## For Thursday meeting

PLAN:  
2ND FLOOR  
BATH 2  
BATH 3

PHIL & MICHELLE WOOD  
3435 N. 140TH. CIRCLE  
OMAHA, NE 68164

PLAN:  
MAIN LEVEL  
HEARTH ROOM

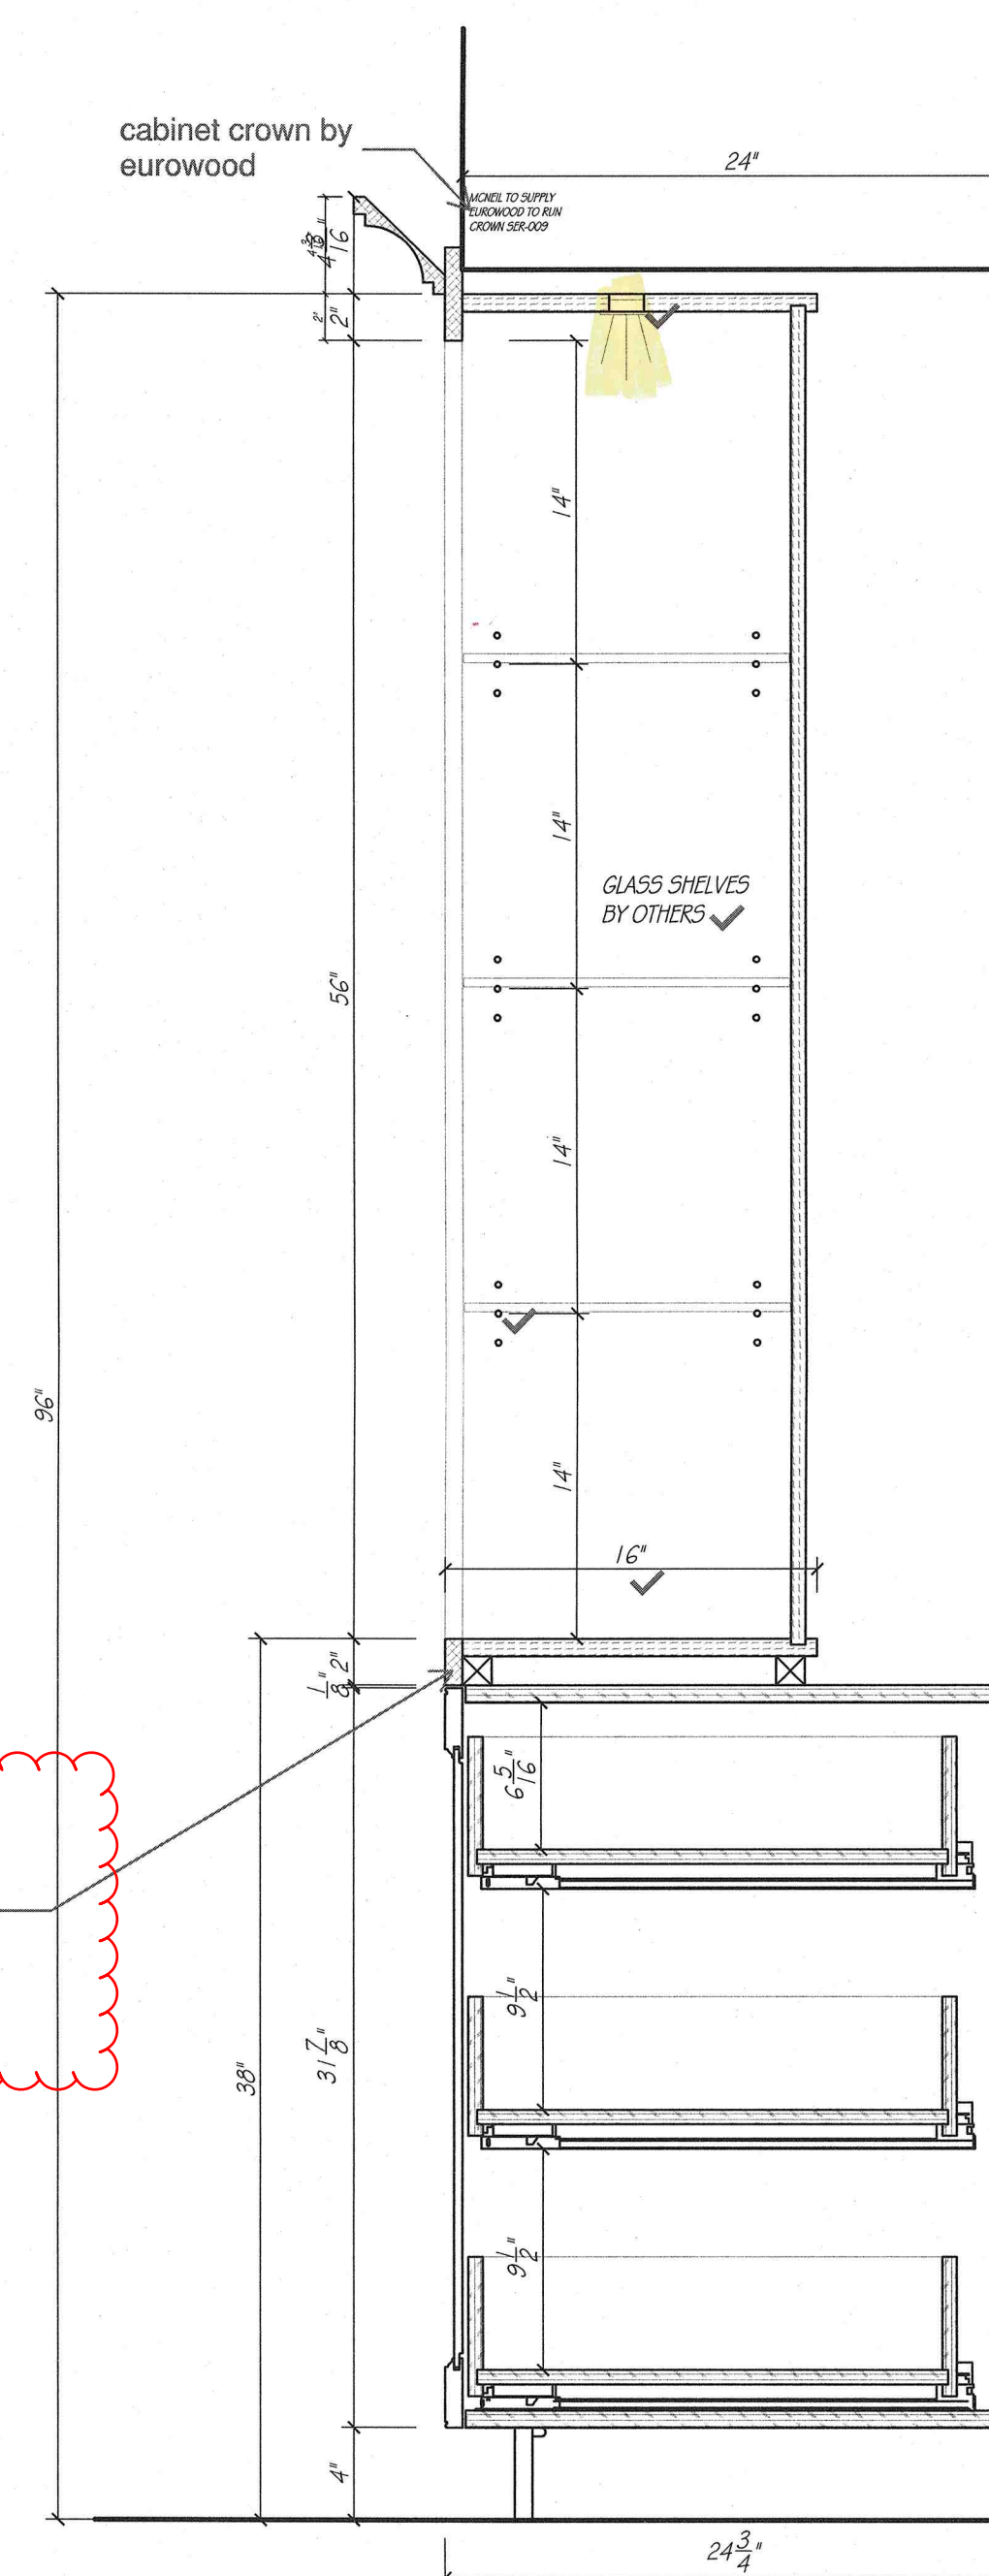
wood "top" to be proud of cabinet fronts by 1/2" - NOT FLUSH - Mad discuss with Steve
